PROBLEM ADVISORY

1. TITLE (Class, Function, Type, etc.) Hybrid Package Ceramic Seal Design		2. DOCUMENT NUMBER FV5-P-09-03
		3. DATE (DD-MMM-YY) 23 JULY 2009
4. MANUFACTURER AND ADDRESS International Rectifier, HiRel Business Unit 2270 Martin Ave. Santa Clara, CA 95050	5. PART NUMBER FSC 5962	6. NATIONAL STOCK NUMBER NOT AVAILABLE

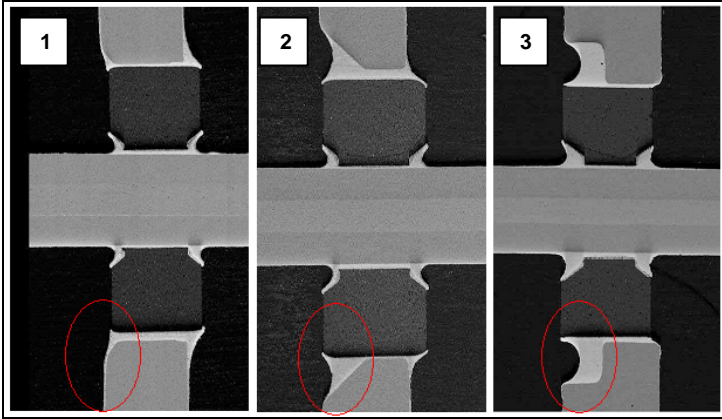
Figure 4 – Cross Sections (SEM Images) showing assembly details of different seal designs. Images 2 and 3 show the deep counter sink and counter bore designs that were shown to be problematic. The braze material fills the areas around the pin (inside the counter sink and counter bore), but the braze does not carry the same compression force as the frame material.

Figure 5 – Shows cross sectional image of ceramic seal with deep counter sink and ceramic cracks due to high tensile force.

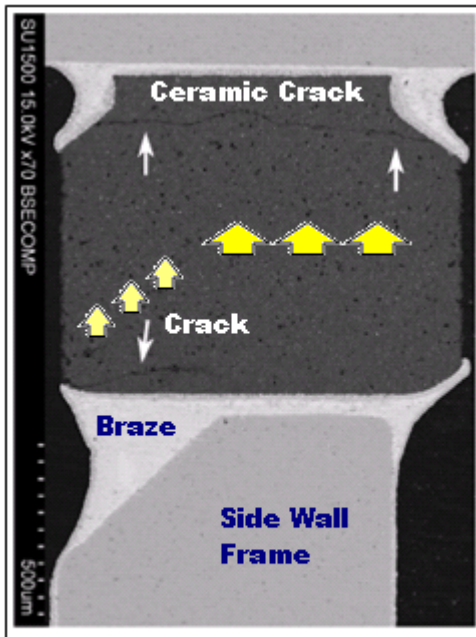
1. The deep counter sink does not allow sufficient compressive forces to be applied to the outer face of the ceramic.
2. The braze joint does not transfer enough compressive force from the frame to the ceramic.
3. This force imbalance creates a tensile force on the ceramic.
4. This condition can cause the ceramic to crack.

- High Compression Force
- Low Compression Force
